Los Angeles International Airport Community Noise Roundtable

LAX Departure Overflights of Palos Verdes and San Pedro

Comments by Jeff Calvagna

6 March 2018

OSHNN8 Standard Instrument Departure (SID)

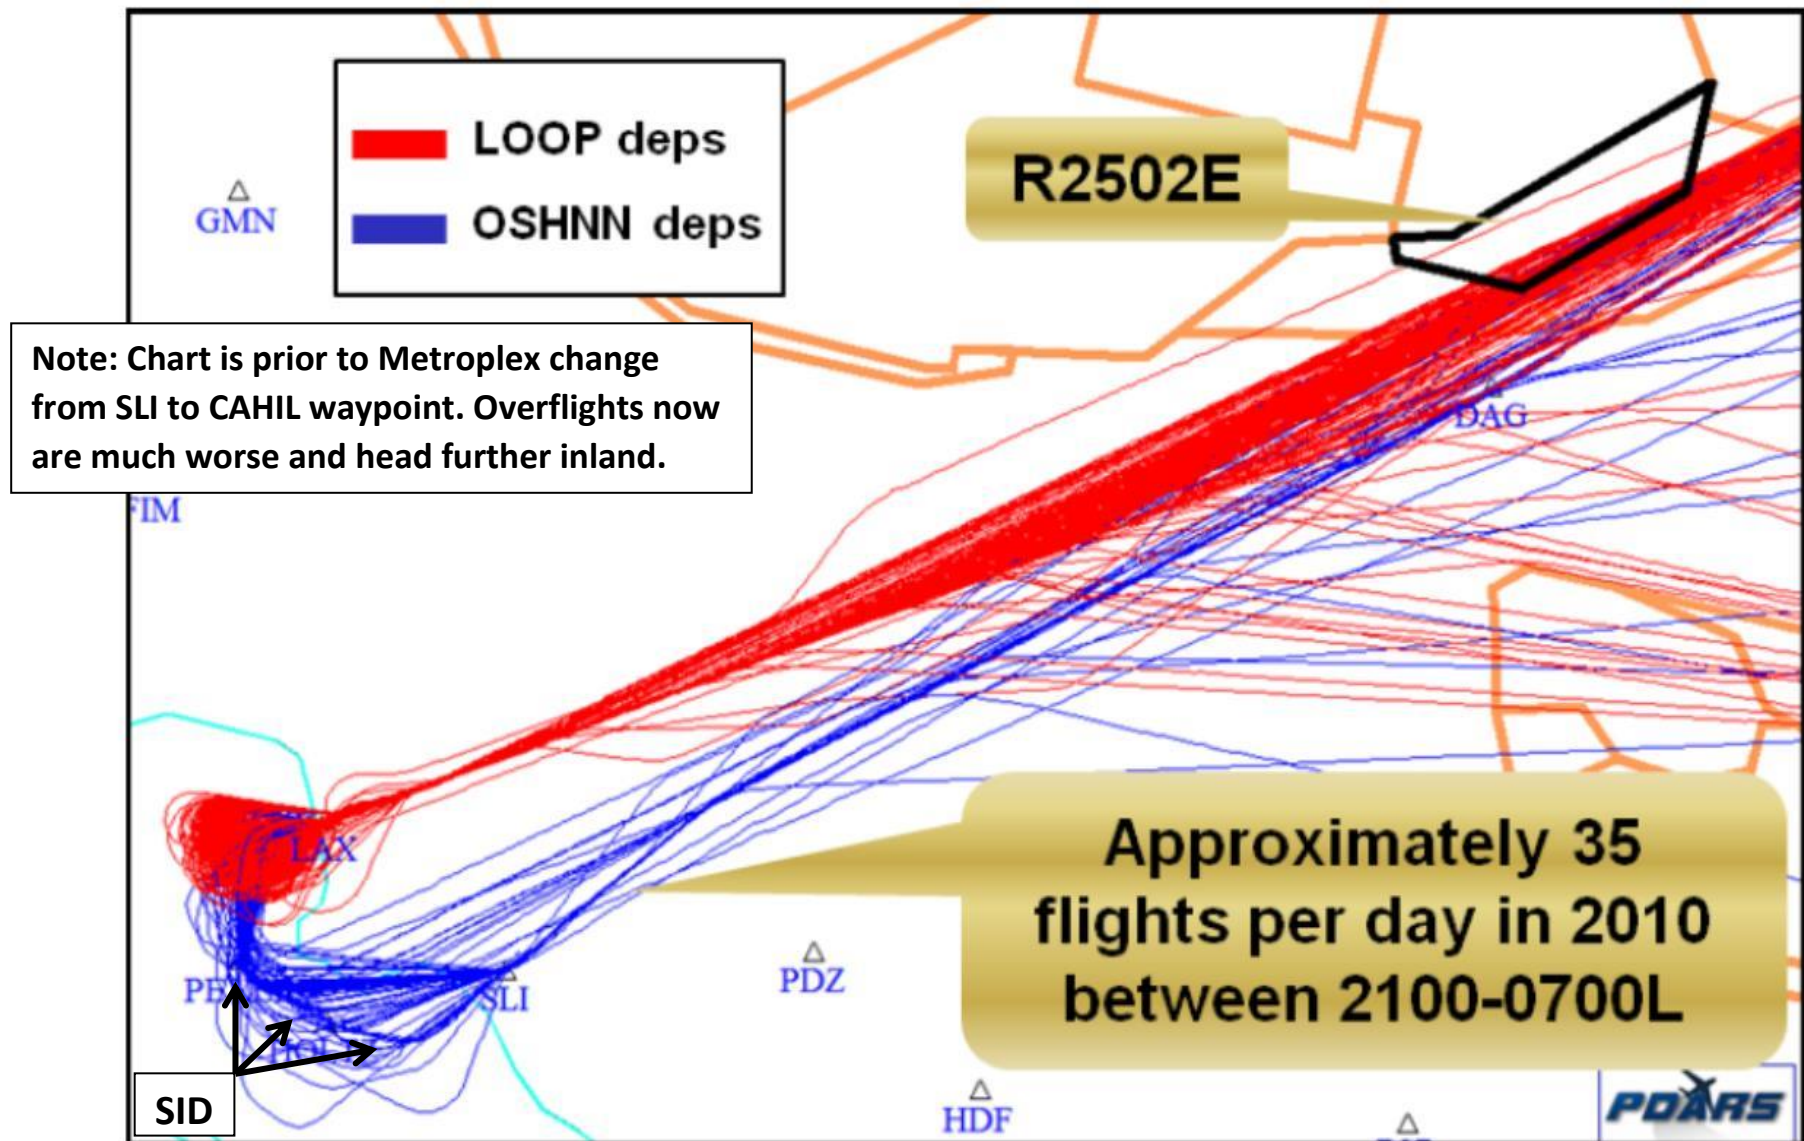
Source of Most Palos Verdes and San Pedro Overflights

OSHNN SID designed for noise abatement yet ATC routinely shortcuts noisy departures over PV and San Pedro Residential Neighborhoods

Graphic from the Metroplex Technical Report shows OSHNN Departures and prevalence of SID Shortcutting

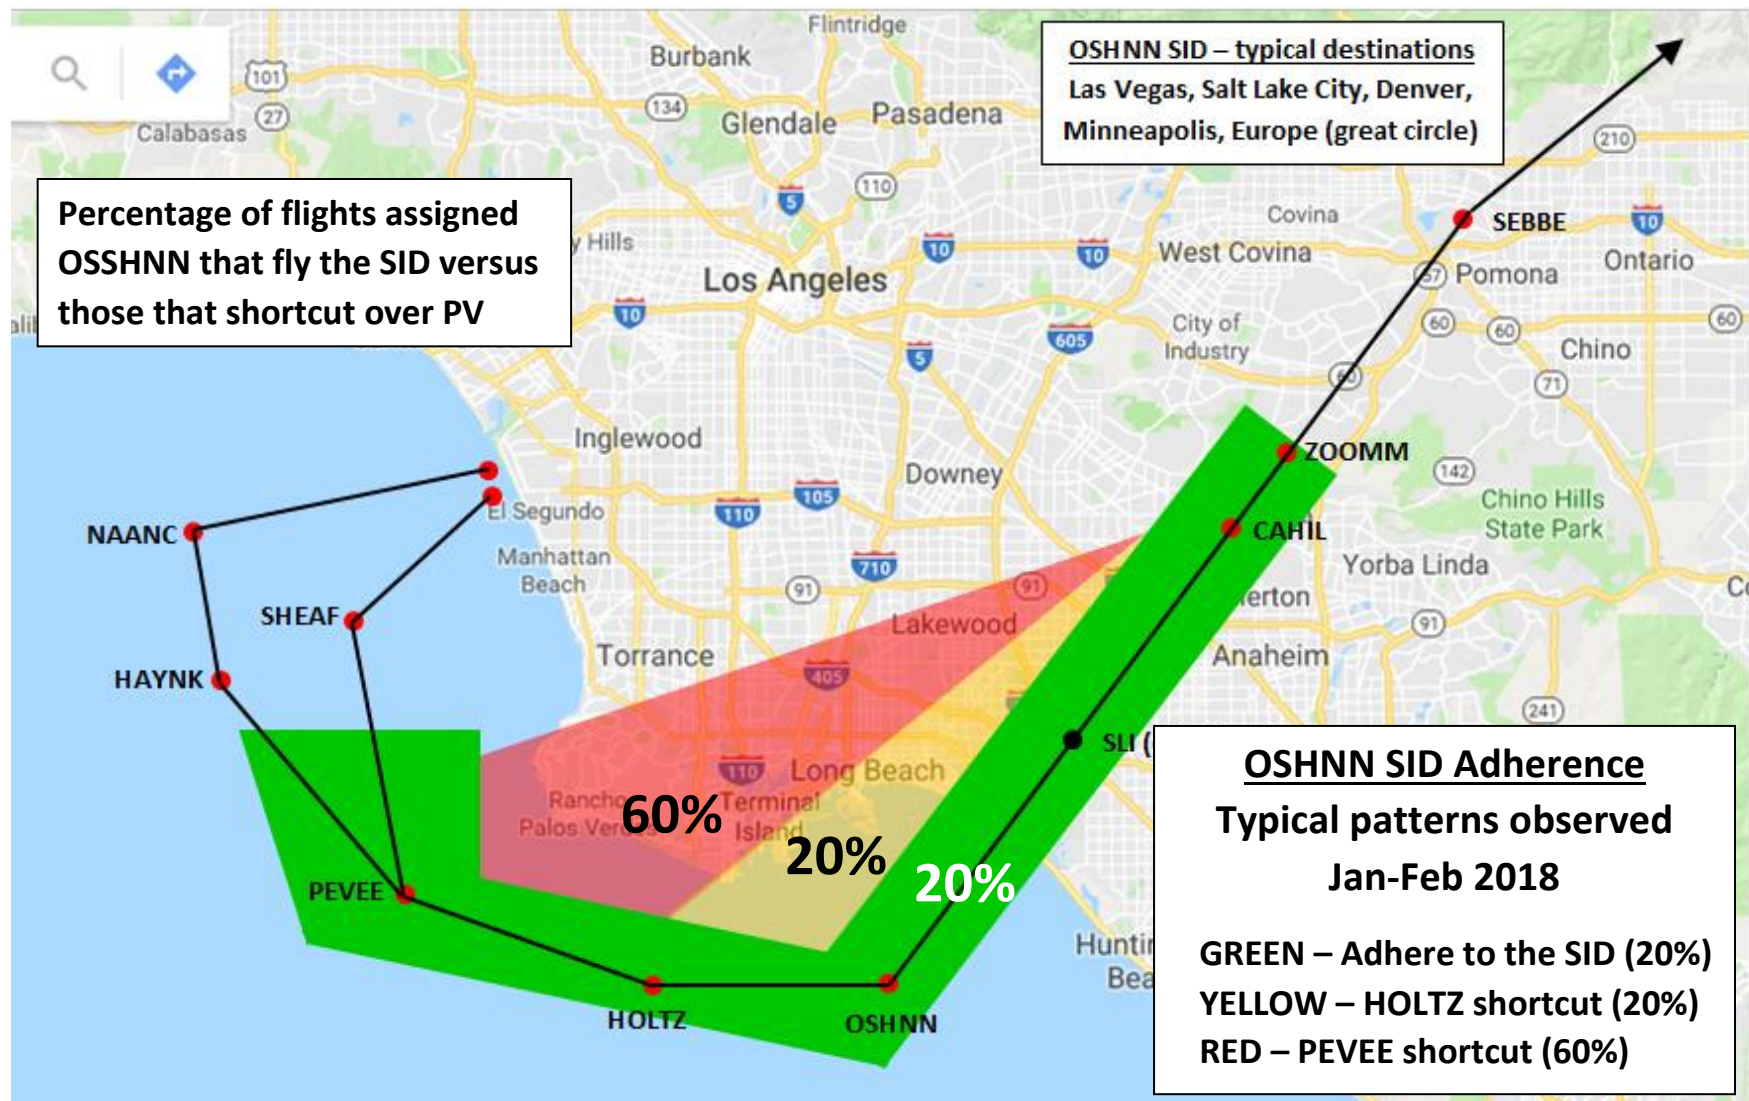
Over 70% of OSHNN Departures shortcut over/near the PV Peninsula

OSHNN Shortcuts – Jan 19th, 9:20 PM to 10:02 PM

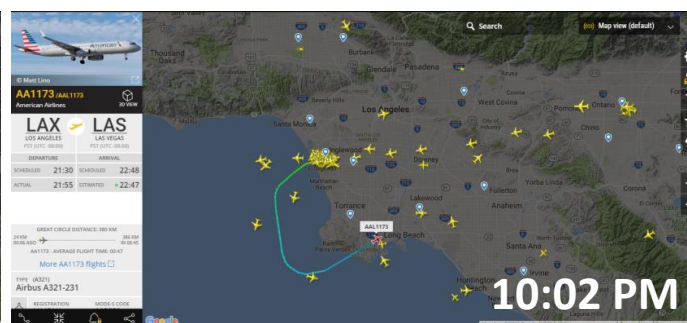
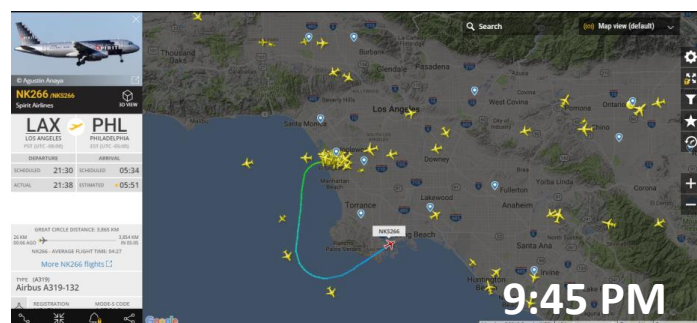
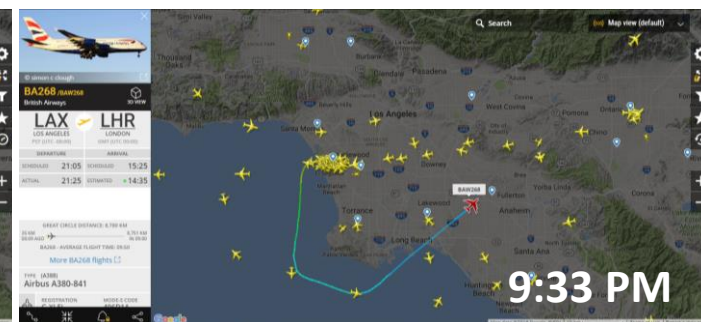
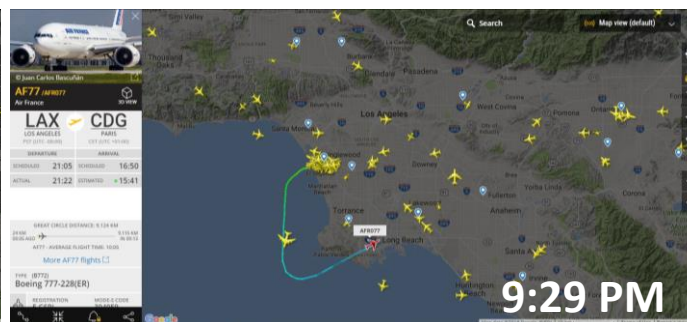
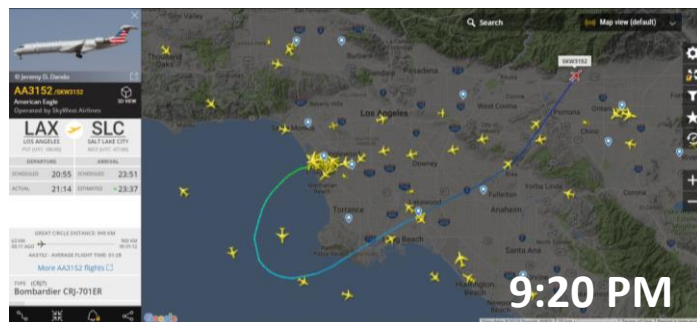
During this evening period, not a single flight correctly flew the SID, all shortcut over or near Palos Verdes

During peak OSHNN usage aircraft can overfly PV every 2-3 minutes

Case Study – Southwest 1283 (LAX → LAS, 9:23 PM Departure)

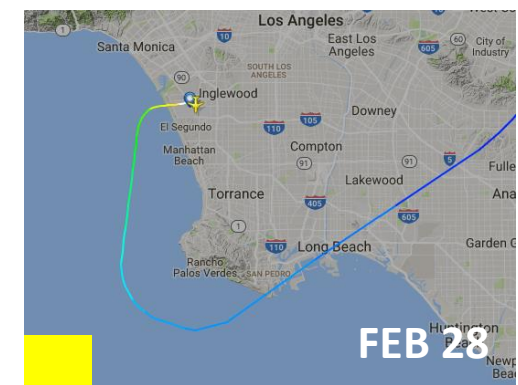
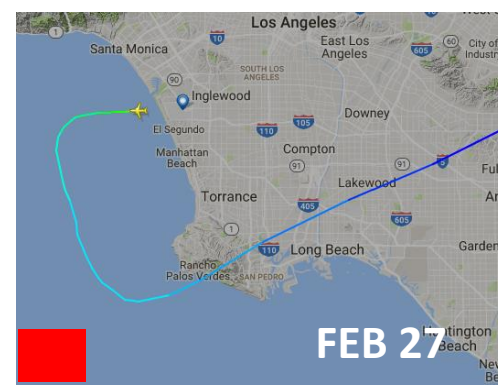
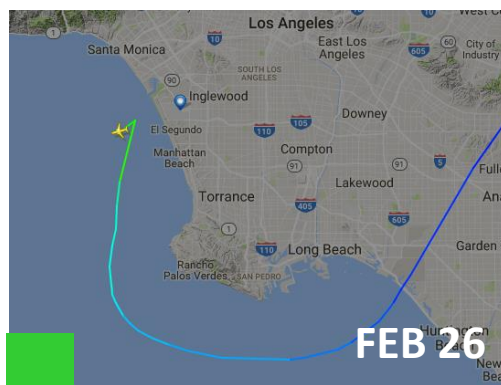
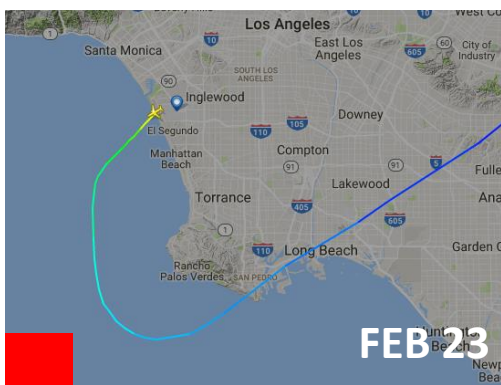
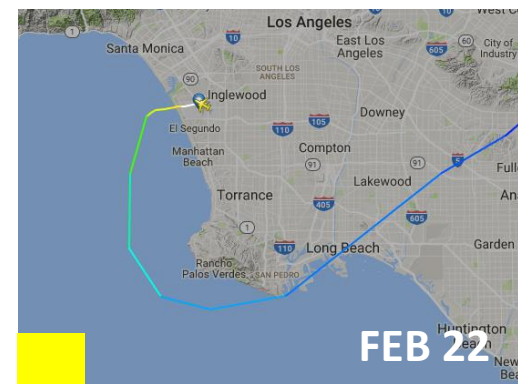
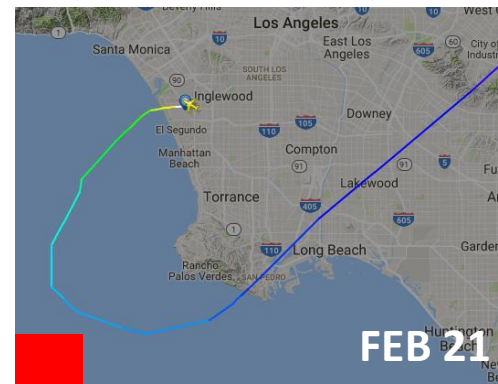
Out of 12 flights, 8 overflowed Palos Verdes/San Pedro (67%)
2 flew the SID (green), 2 HOLTZ shortcut (yellow), 8 PEVEE shortcut (red)

Case Study – Delta 1404 (LAX → SLC, 6:00 AM Departure)

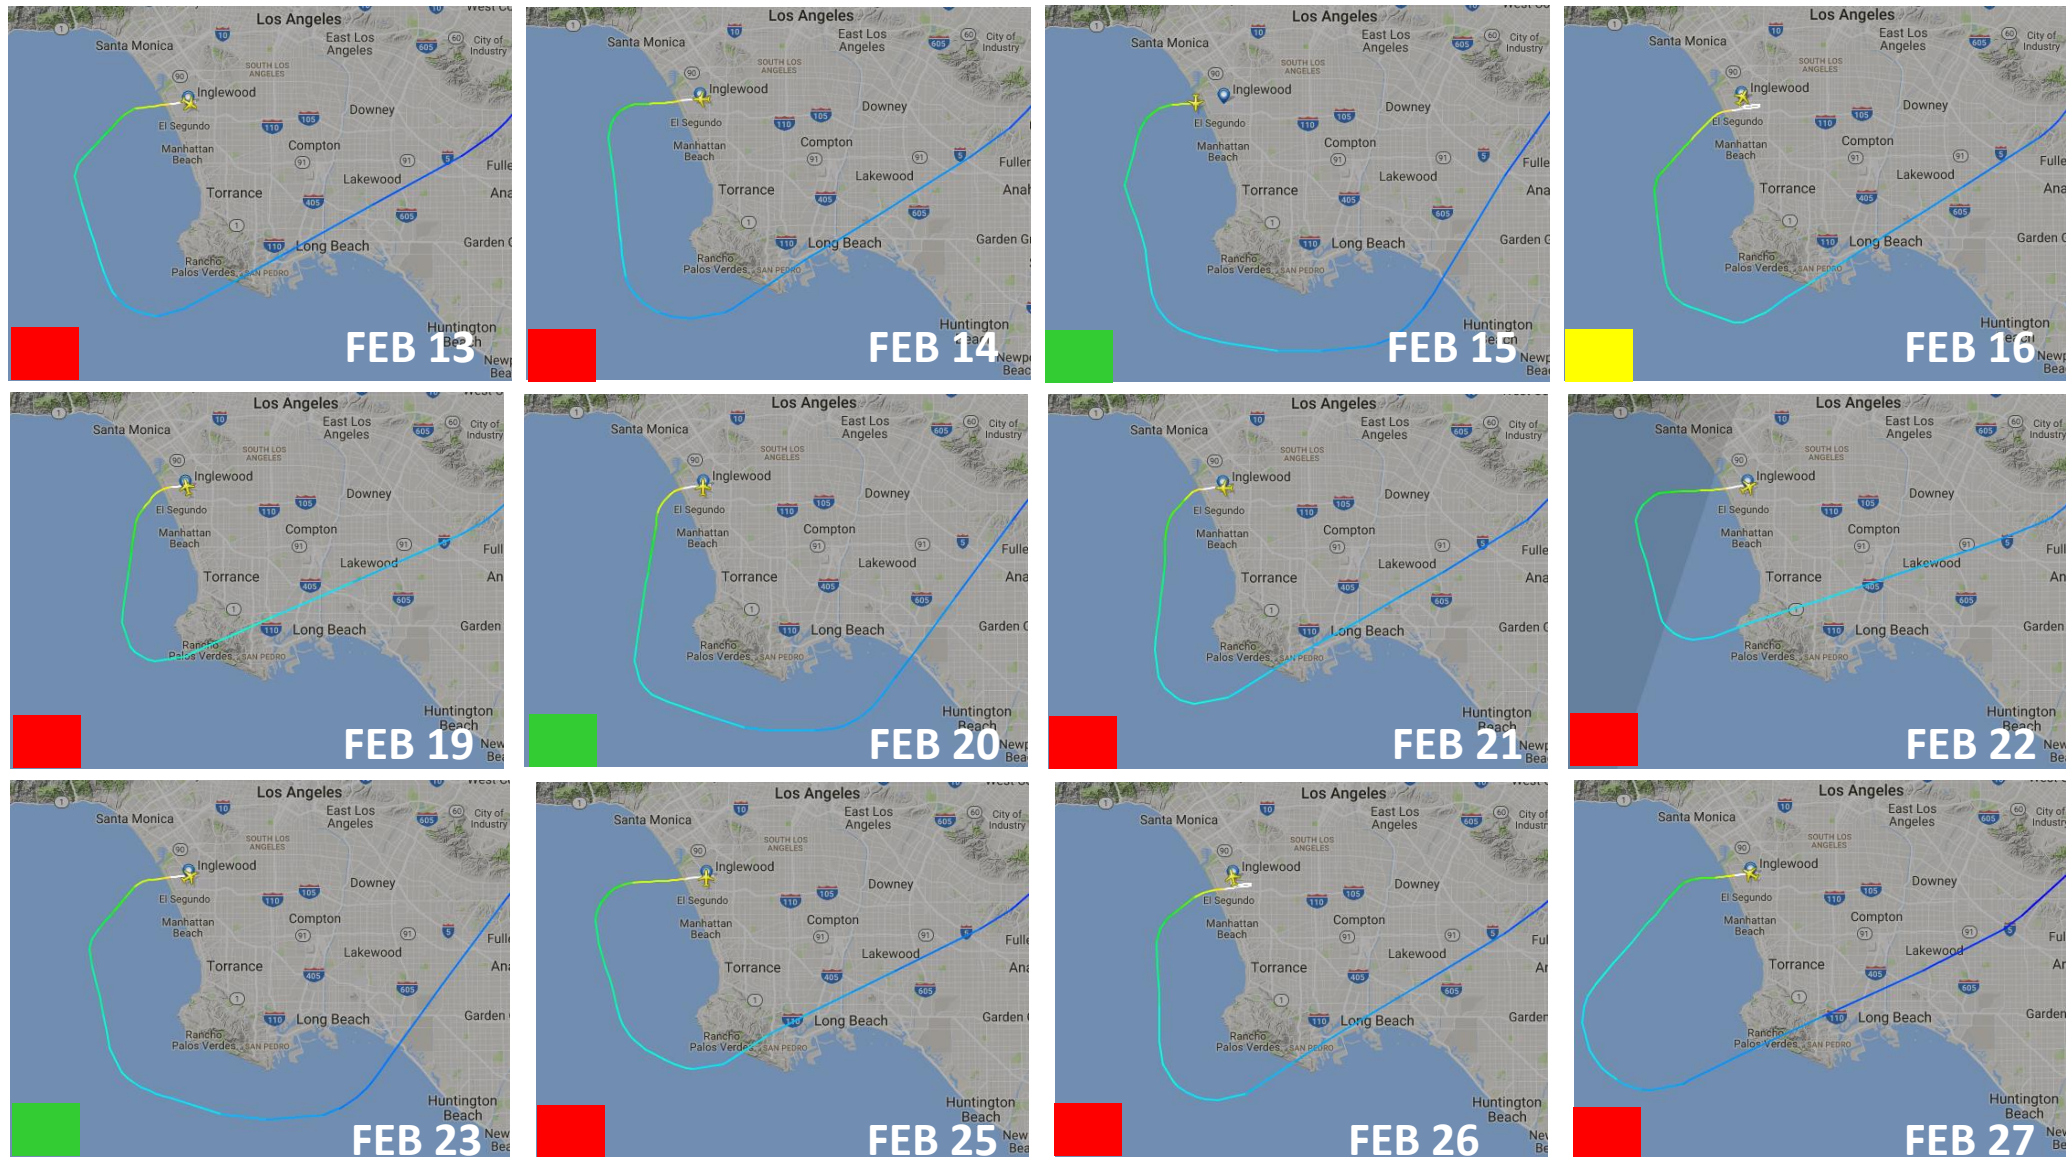
Out of 12 flights, 8 overflow Palos Verdes/San Pedro (67%)
3 flew the SID (green), 1 HOLTZ shortcut (yellow), 8 PEVEE shortcut (red)

Why is This Happening? (ATC Vector “Direct to CAHIL”)

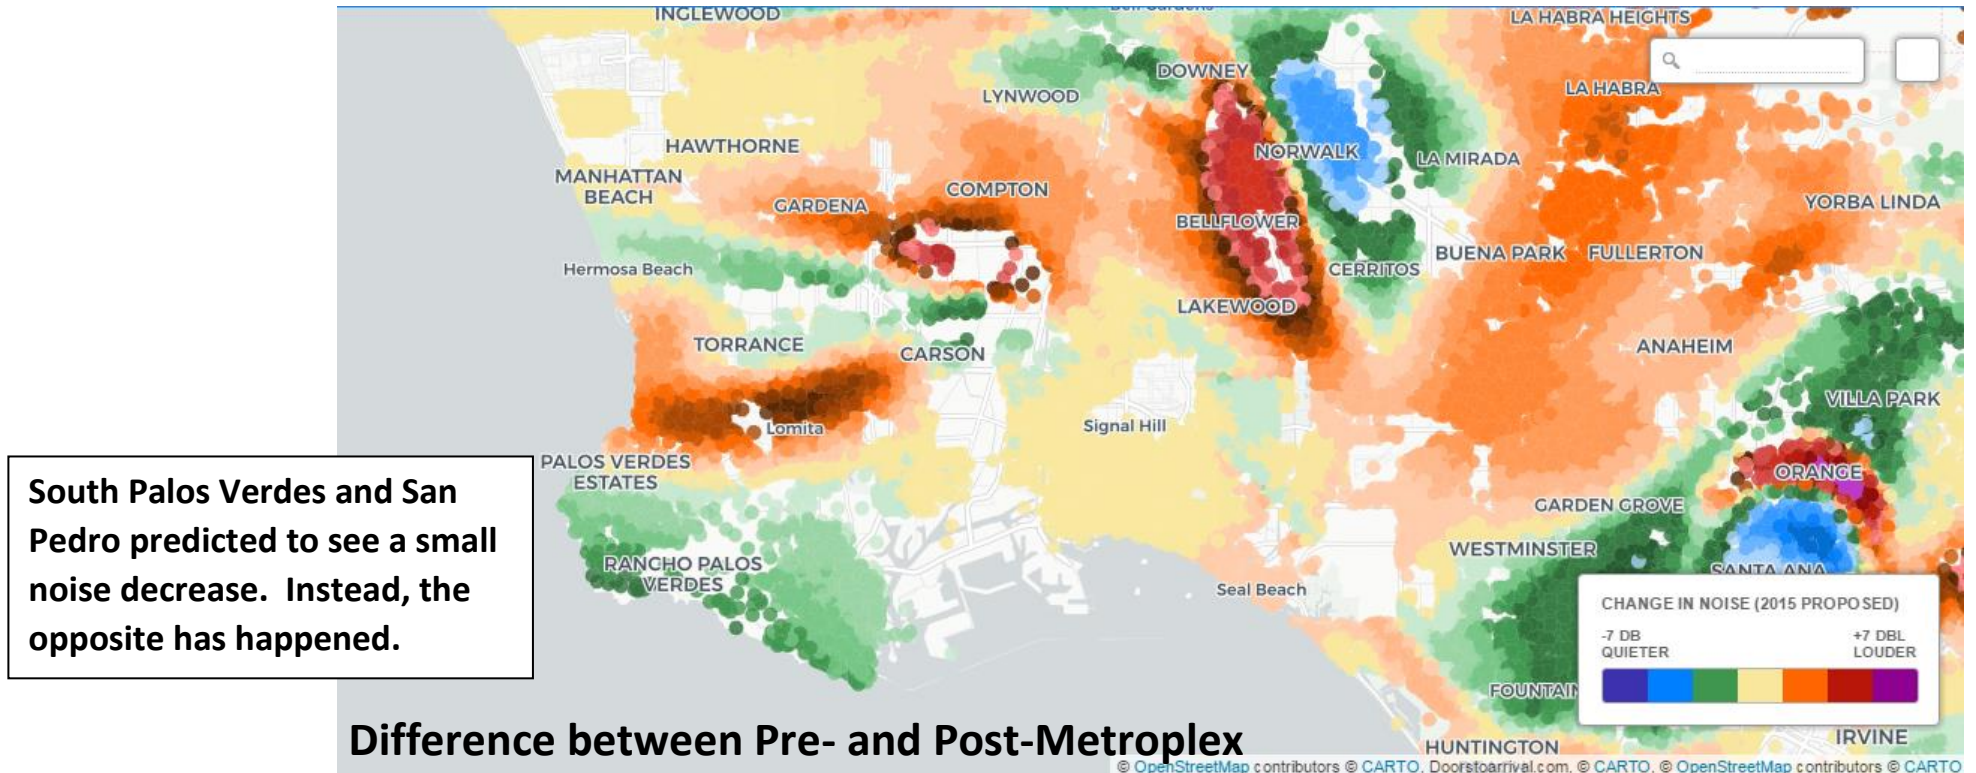
- OSHNN is longer and takes more time – particularly if the aircraft had originally filed for the ORCKA (loop) departure
- OSHNN is complex and slower – three turns, at PEVEE, HOLTZ, and OSHNN
- OSHNN is busy – PEVEE to OSNNH leg shared with the DOTSS departure
 - More ATC intervention needed to de-conflict with DOTSS traffic
 - Speed restrictions often needed to maintain separation
 - Altitude restrictions due to Long Beach (LGB) southern departures
- OSHNN delays ATC hand-off from SoCal TRACON to LA Center (ZLA)

Since there is no PV air traffic, “Direct to CAHIL” is a free pass SoCal TRACON uses to make these concerns go away, rarely is it “required for spacing”
